TPB Ref.: A/YL-TYST/1334

**Temporary Open Storage of Construction Machinery and Construction Materials, Recycling Materials and Used Electrical Appliances with Ancillary Workshop for a Period of 3 Years at Lots 366 RP (Part), 371 S.B (Part), 372 S.A, 372 S.B, 373, 374, 375 RP (Part), 376 (Part), 377 (Part), 378 (Part), 379, 380, 381 RP (Part), 458 (Part), 459, 460, 461, 462, 463, 464, 471, 472, 1323 (Part), 1324, 1325 (Part), 1337 (Part), 1338 (Part), 1339, 1340 (Part), 1341, 1342, 1344 (Part), 1345 (Part), 1346 (Part), 1349 (Part), 1350 (Part), 1351 (Part), 1353 (Part), 1354, 1355 (Part), 1356 S.A (Part), 1356 S.B, 1357, 1358 RP, 1359, 1360, 1361, 1362, 1363 RP, 1365 (Part), 1366 RP (Part) in D.D.119 & Adjoining Government Land, Yuen Long, N.T.**

As discussed, please find the following comments from DSD on your submitted Drainage Impact Assessment for your reference:

## DRAINAGE IMPACT ASSESSMENT

Drawing No:  
 D04

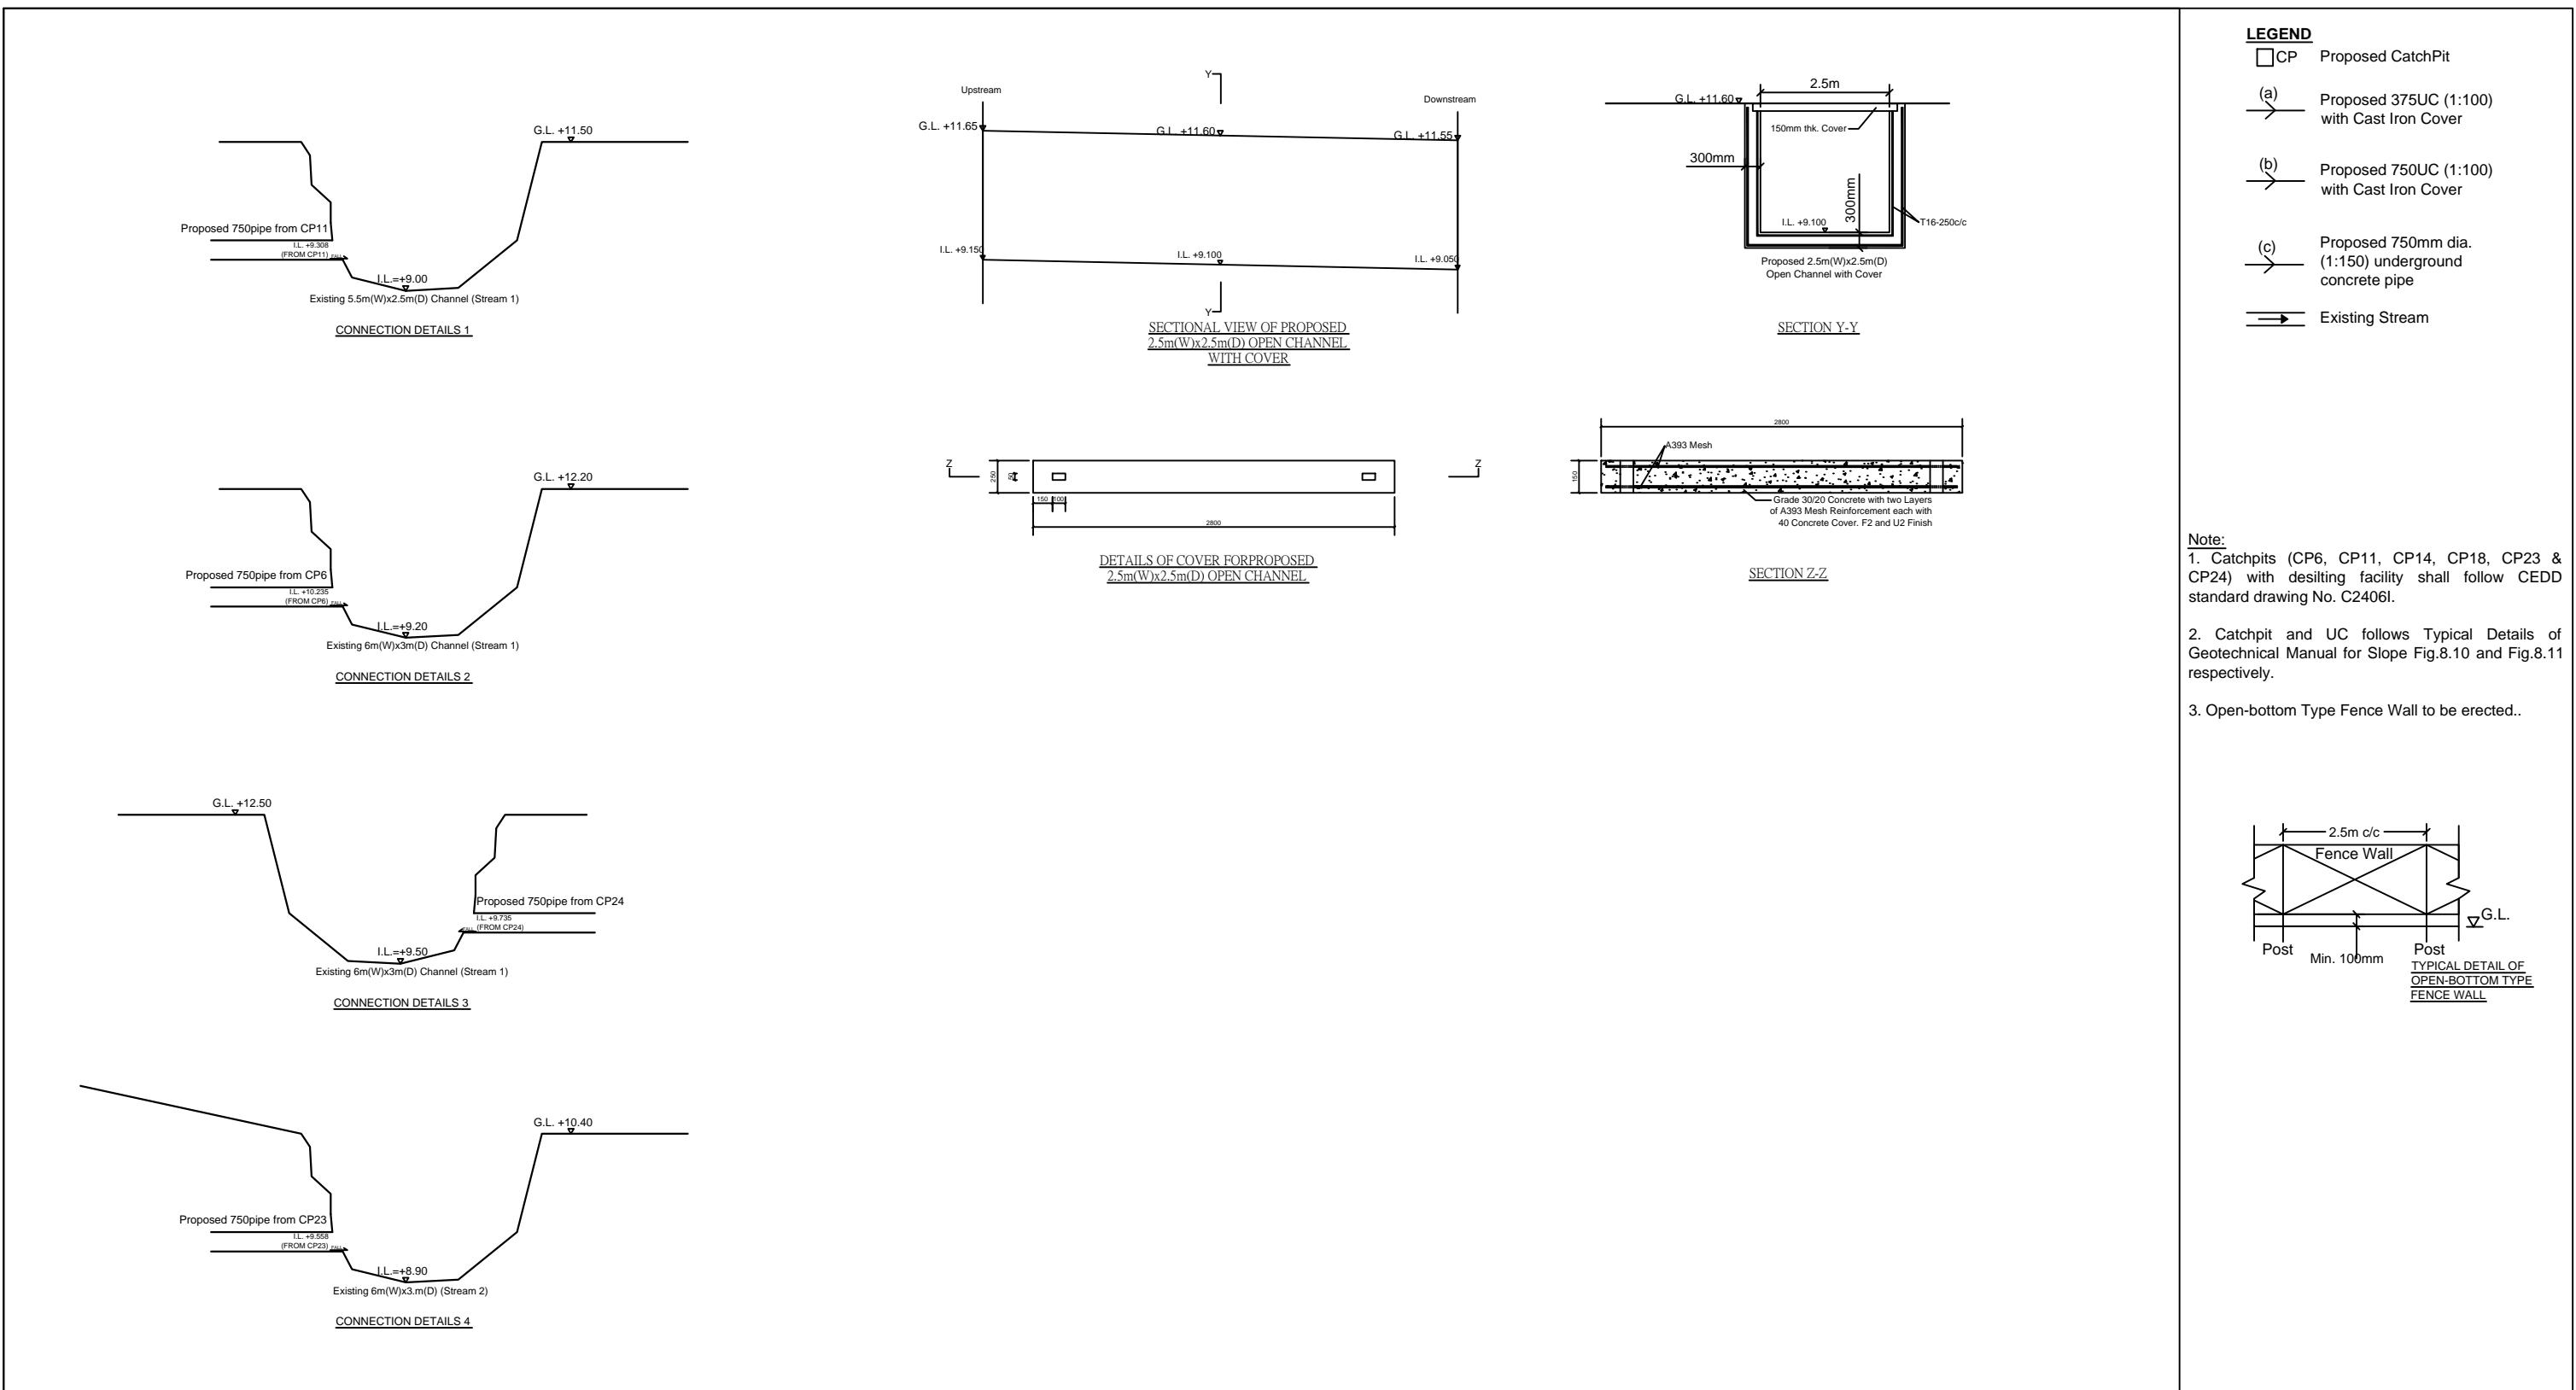
- Please provide details/section of the proposed 2.5m(W)x1m(D) open channel with cover, also indicating the adjoining stream bed levels. **Details are presented in Drawing D05**

- Please provide details/section of the proposed open-bottom type fence wall, and also indicate the extent of fence wall to be erected on plan. **It is presented in the Drawings.**

- Please advise if any site formation/levelling works to be carried out under this application. Cross sections showing the existing and proposed ground levels of the captioned site with respect to the adjacent areas should be given. **No site formation/levelling works to be carried out.**

- Cross sections are provided in Drawing D04**
- The existing stream 1 and stream 2, to which the applicant proposed to discharge the stormwater from the subject site was not maintained by this office. The applicant(s) shall resolve any conflict/disagreement arisen for discharging the runoff from the application site(s) to the proposed discharge point(s). In the case that it is a local village drains, DO/YL should be consulted. Moreover, the applicant(s) should ensure that this drainage system and the existing downstream drains/channelsstreams have adequate capacity to convey the additional runoff from the application site(s). Regular maintenance should be carried out by the applicant(s) to avoid blockage of the system. **Noted.**

CATCHPIT WITH TRAP  
(SHEET 1 OF 2)

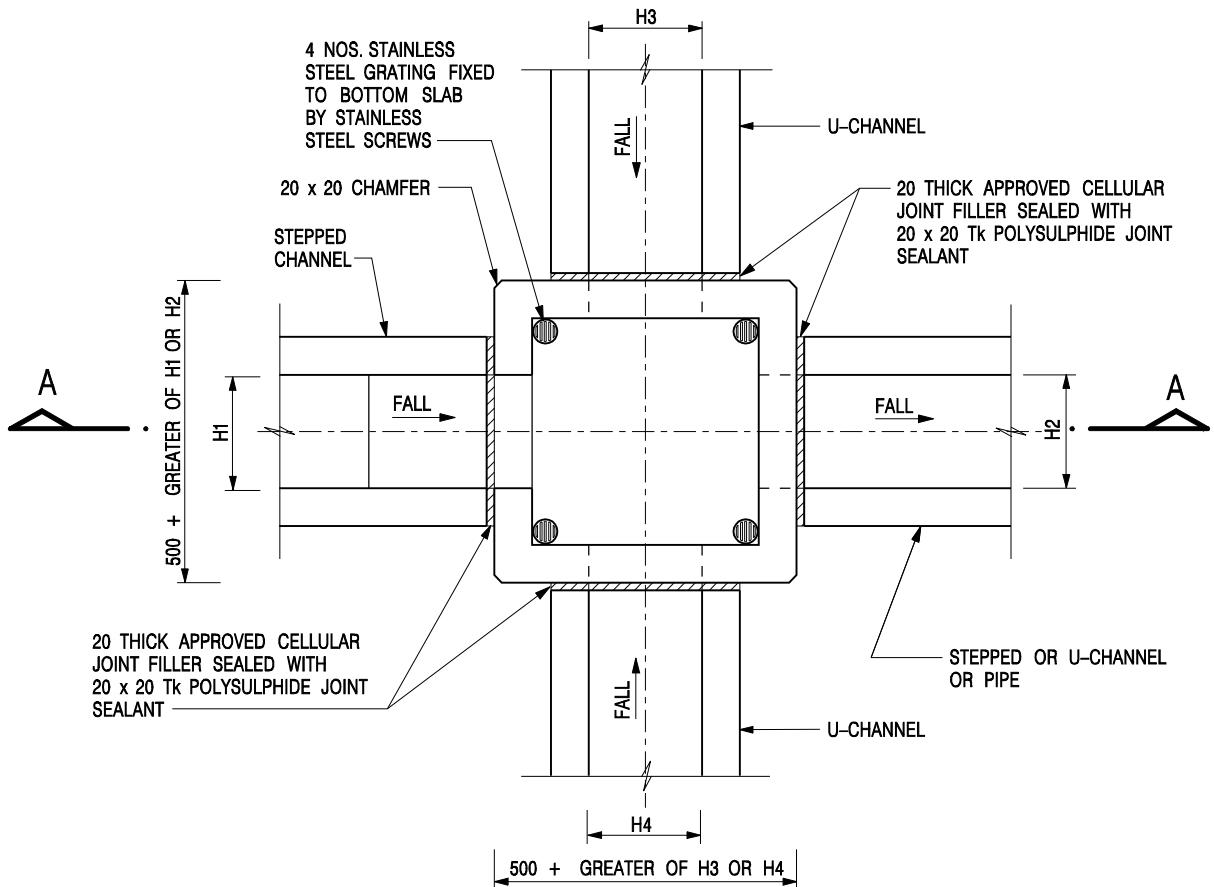
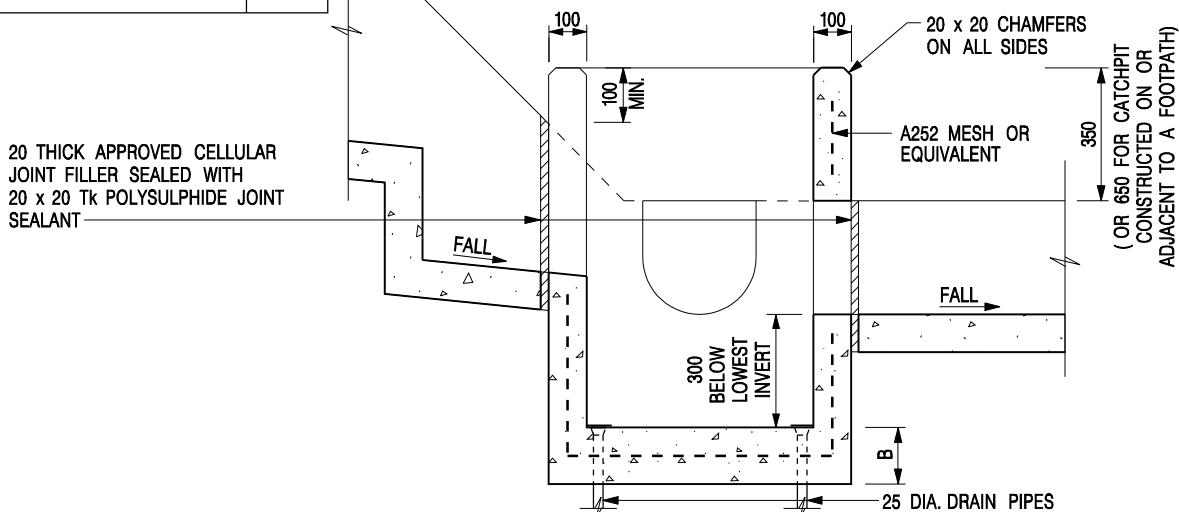
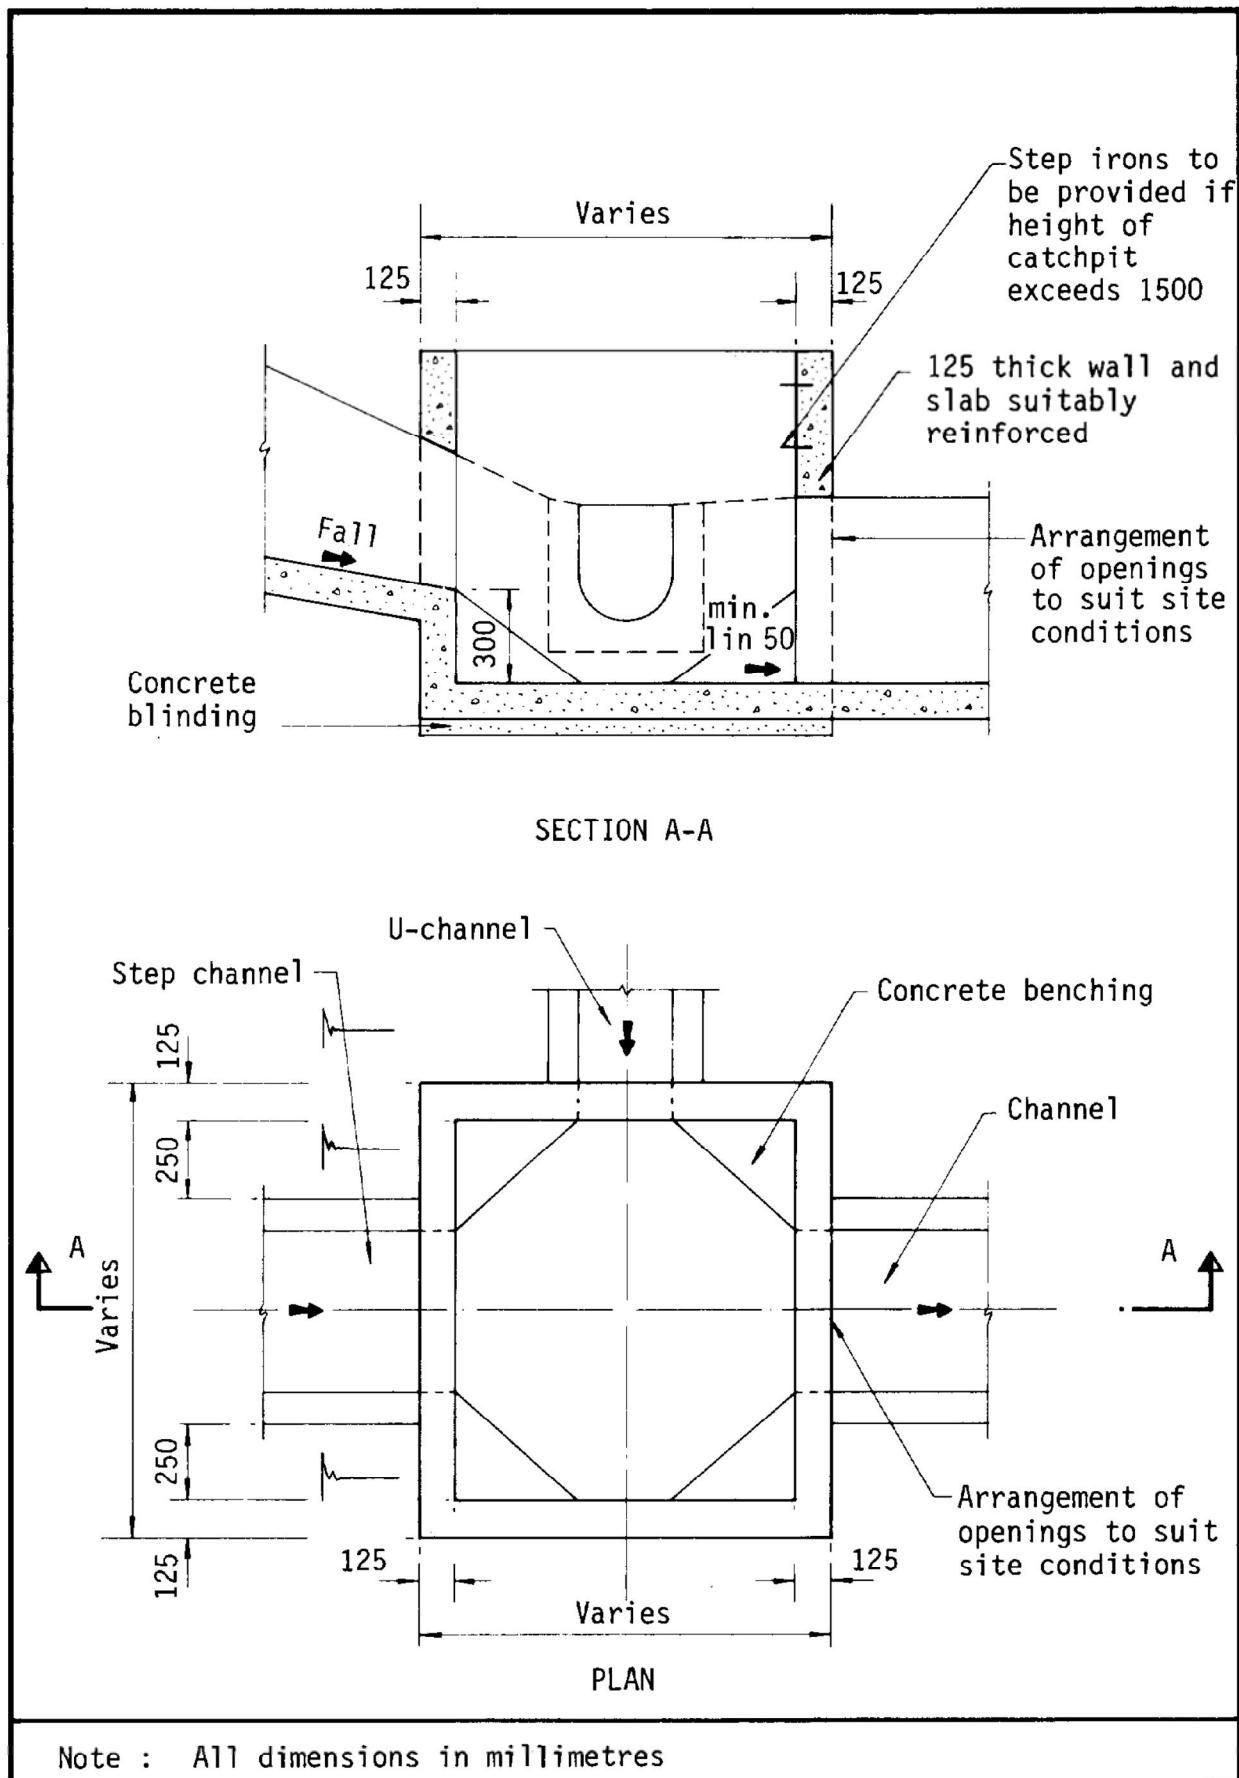
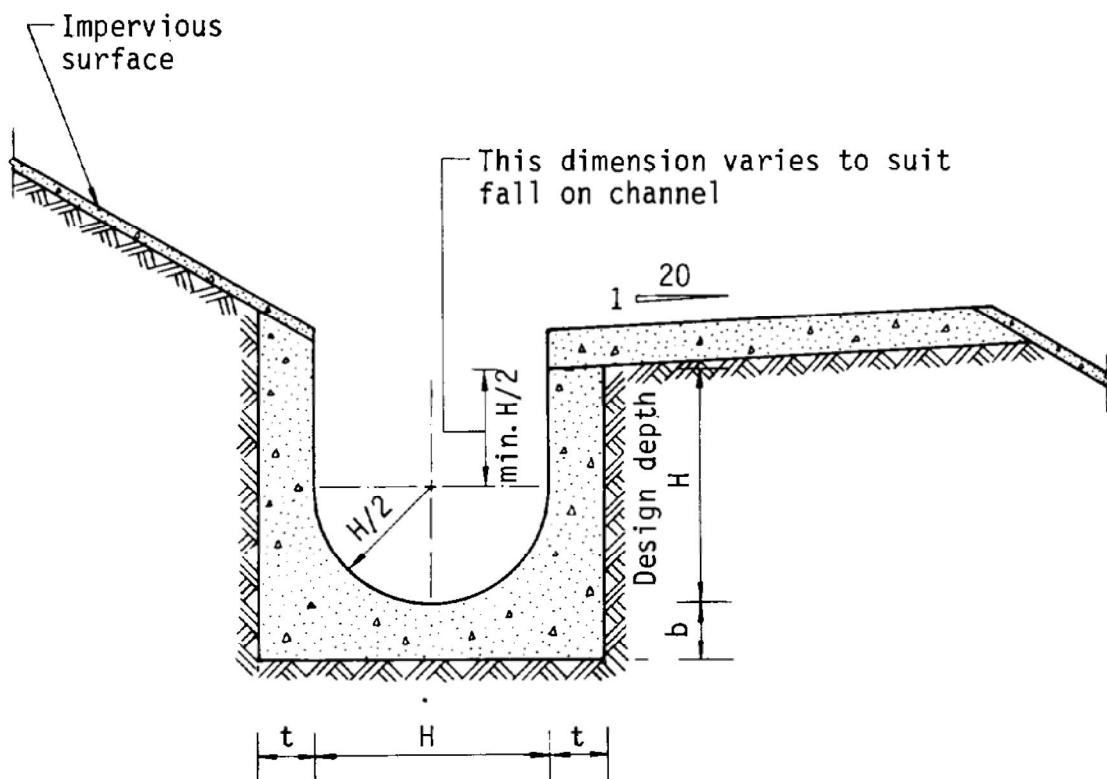
- Standard details should be provided to indicate the sectional details of the proposed u-channel and the catchpit/sand trap. **Standard details are provided.**

Figure 4

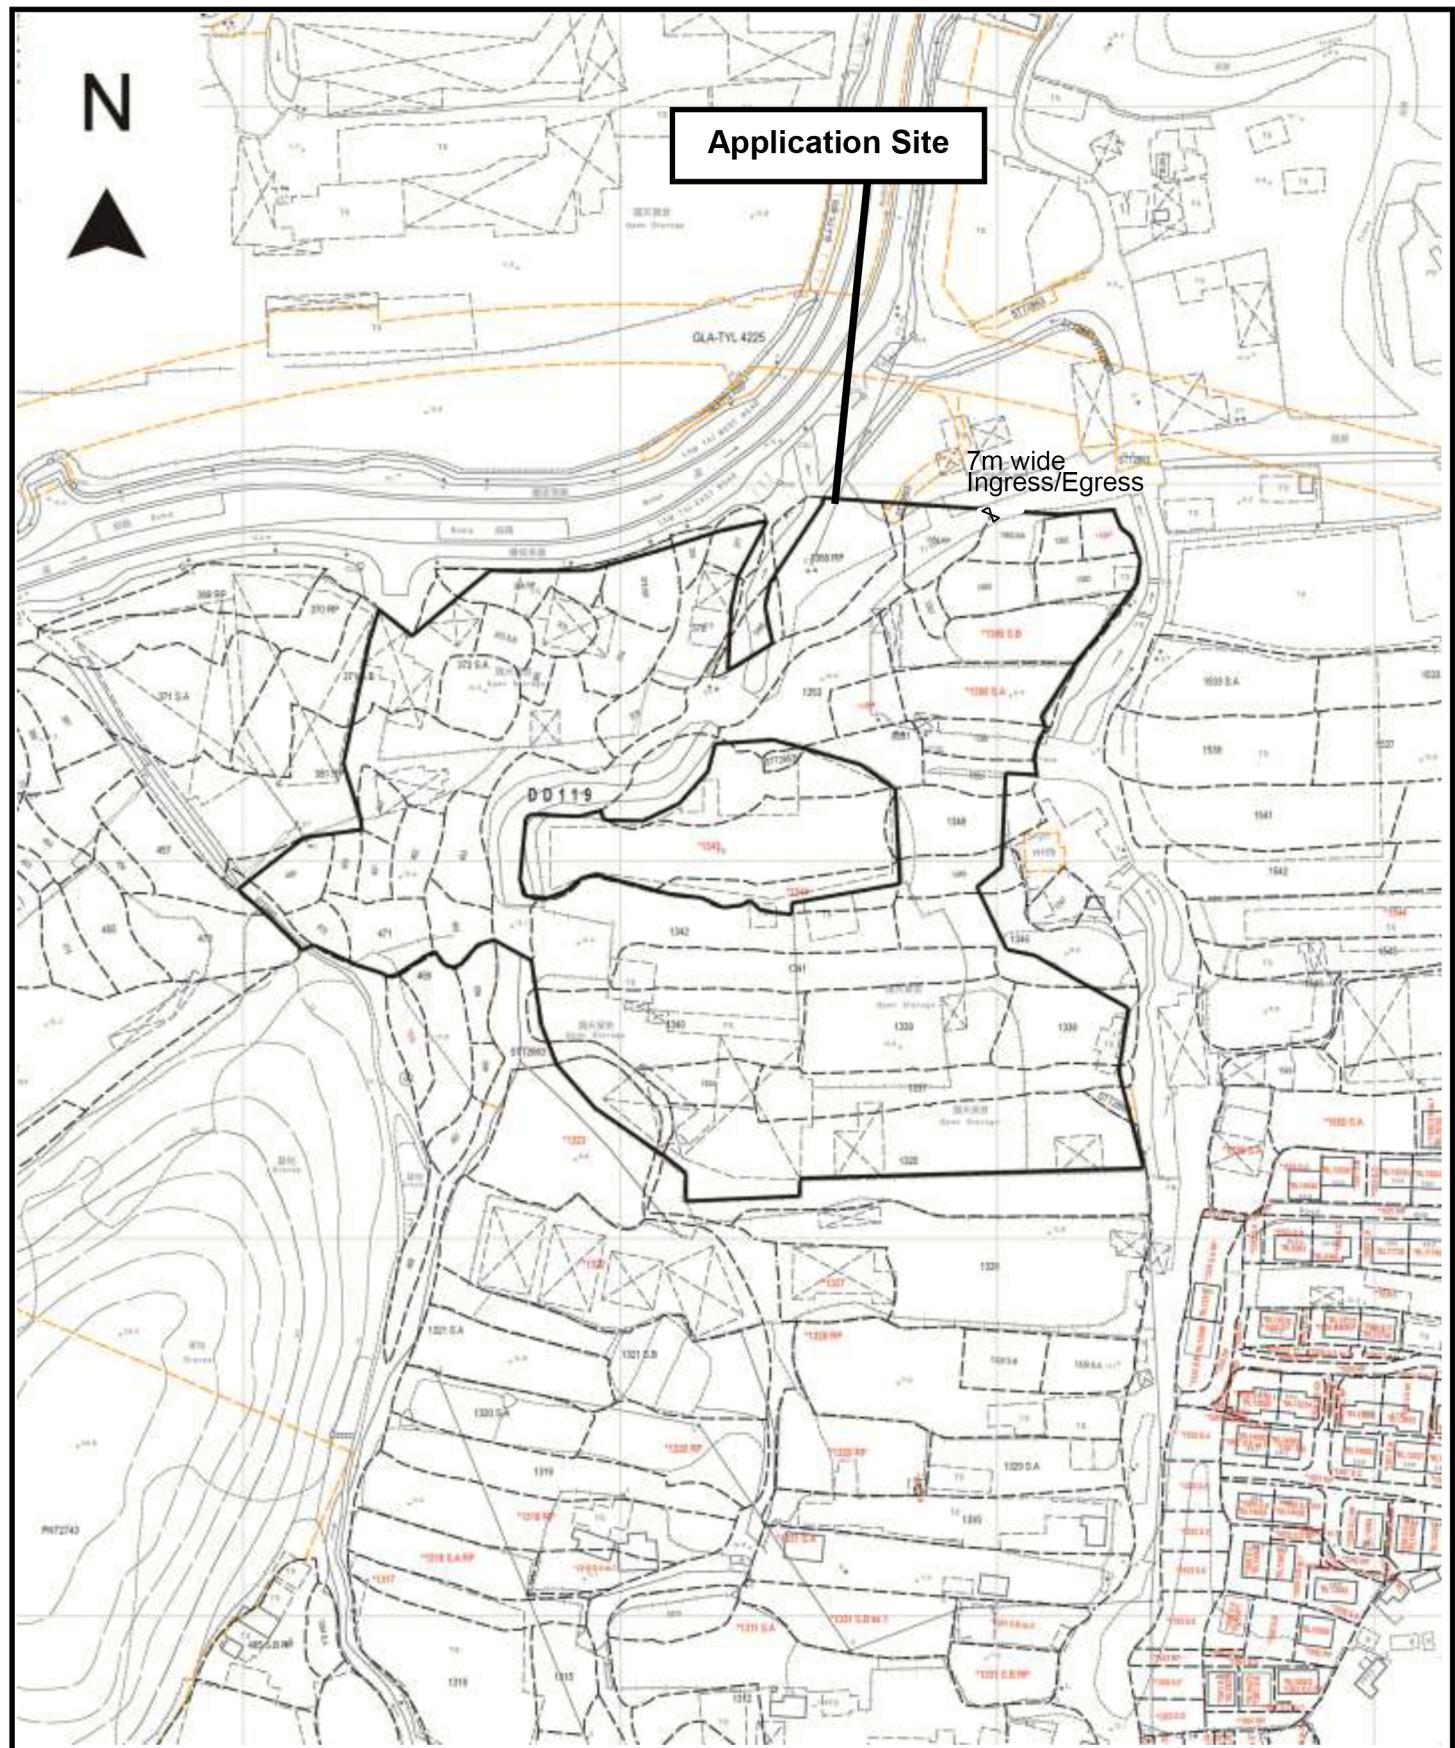
Transport Department's comments	Applicant's response
(a) Would you please ask the applicant's to indicate the vehicular run-in/out and dimension of it on its layout plan for my further consideration.	Noted. Please see attached Figure 4.
